DUANE ARNOLD ENERGY CENTER

AMENDMENT TO FACILITY OPERATING LICENSE

Amendment No. 172
License No. DPR-49

ATTACHMENT TO LICENSE AMENDMENT NO. 172

Figure 3.6-1. Pressure versus Minimum Temperature Valid to Sixteen Full Power Years, per Appendix G of 10CFR50

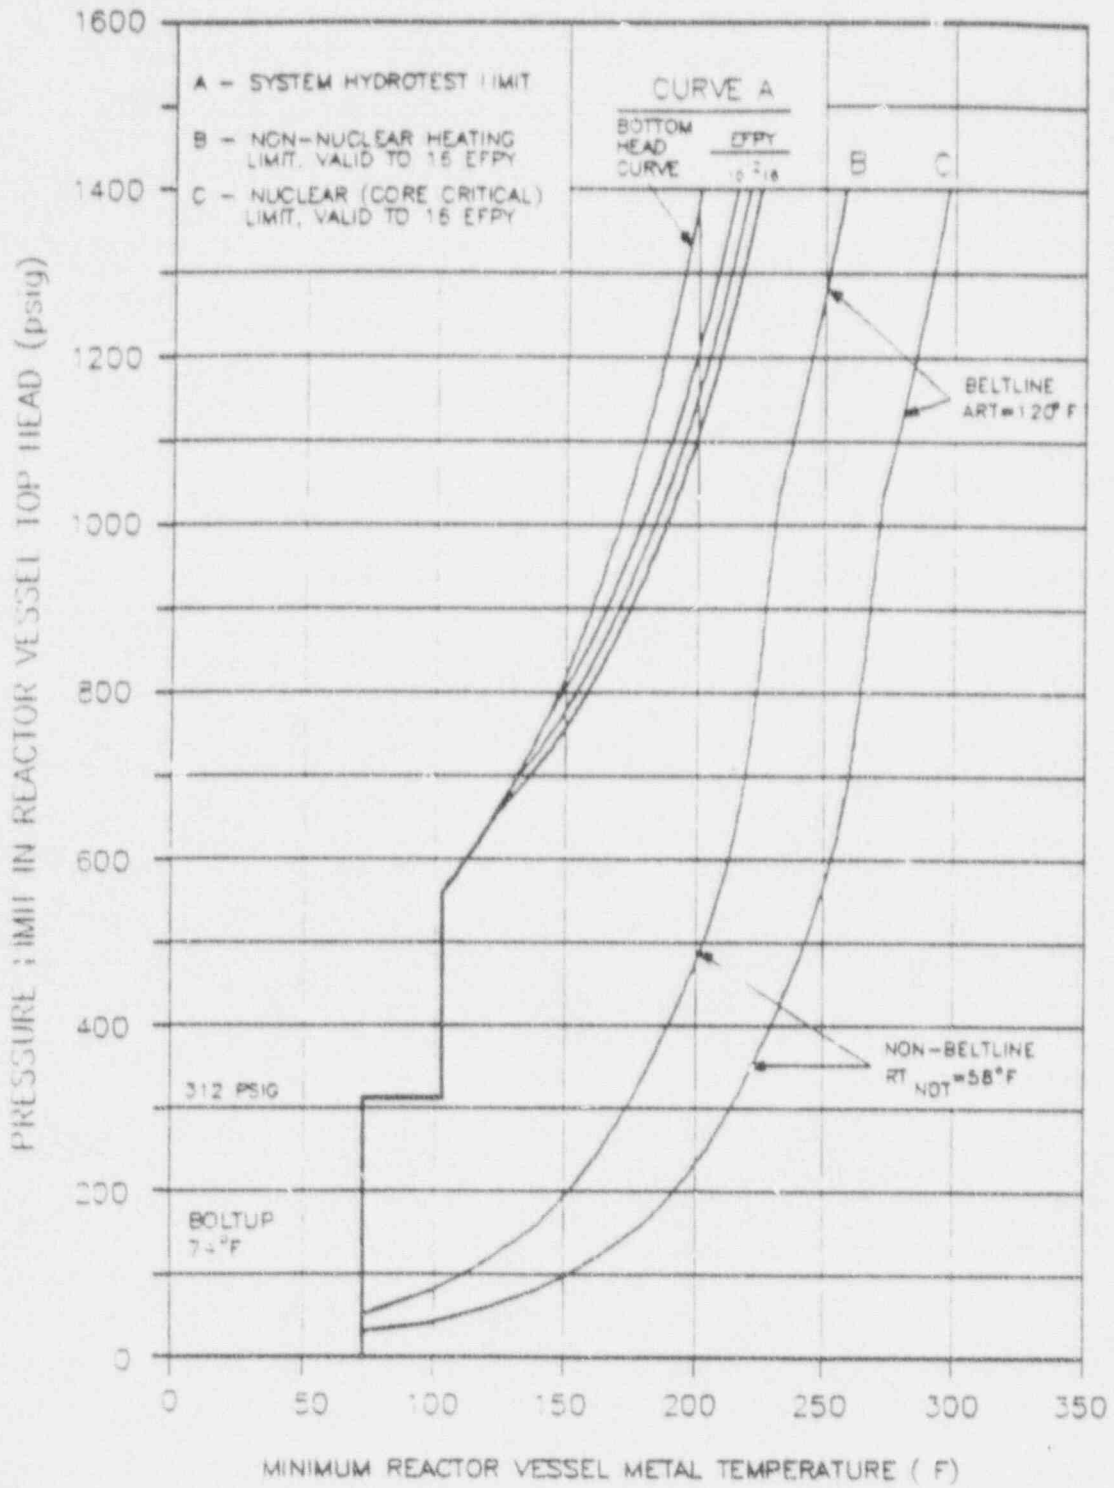
2. The reactor vessel shall be vented and power operation shall not be conducted unless the reactor vessel temperature is equal to or greater than that shown in Curve C of Figure 3.6-1. Operation for hydrostatic or leakage tests, during heatup or cooldown, and with the core critical shall be conducted only when vessel temperature is equal to or above that shown in the appropriate curve of Figure 3.6-1. Figure 3.6-1 is effective through 16 effective full power years. At least six months prior to 16 effective full power years new curves will be submitted.

The operating limits in Figure 3.6-1 are derived in accordance with 10CFR50 Appendix G, May, 1983 and Appendix G of the ASME Code. Conditions in three regions influence the curves: the closure flange region, the non-beltline region which includes most nozzles and discontinuities, and the beltline region which is irradiated with fluence above 10^{17} n/cm² during the vessel operating life. Irradiation has caused an increase in the nil-ductility temperature (RT_{NDT}) of the beltline materials, to the point where the beltline region impacts the pressure-temperature limits for the vessel. For Figure 3.6-1, effective to 16 EFPY, the beltline which has an RT_{NDT} of 40°F is limiting at higher pressures. The non-beltline regions which generally experience higher stresses at nozzles and discontinuities are limiting at lower pressures. The limiting RT_{NDT} of 58°F for the Standby Liquid Control Nozzle (N10) is the highest RT_{NDT} of any component in the non-beltline region.

Neutron flux wires and samples of vessel material are installed in the reactor vessel adjacent to the vessel wall at the core midplane level. The first capsule was removed after fuel cycle 7, at 6 effective full power years. The neutron flux wires tested were used to determine the end-of-life fluence at the $1/4 T$ depth in the vessel wall of $3.6 \times 10^{18} \text{ n/cm}^2$. Irradiated and unirradiated Charpy specimens were tested. Since the test showed that the limiting beltline material initial RT_{NDT} and the RT_{NDT} shift are the same as those previously predicted, there was no need to change the curves of Figure 3.6-1 based on Surveillance Materials Testing. However, an adjusted reference temperature, based on the fluence, nickel content and copper content of the material in question, can be predicted using the recommendations of Regulatory Guide 1.99, Revision 2, "Radiation Embrittlement of Reactor Vessel Materials." The pressure-temperature curves of Figure 3.6-1, includes predicted adjustments for this shift in RT_{NDT} at the end of 16 EFPY.
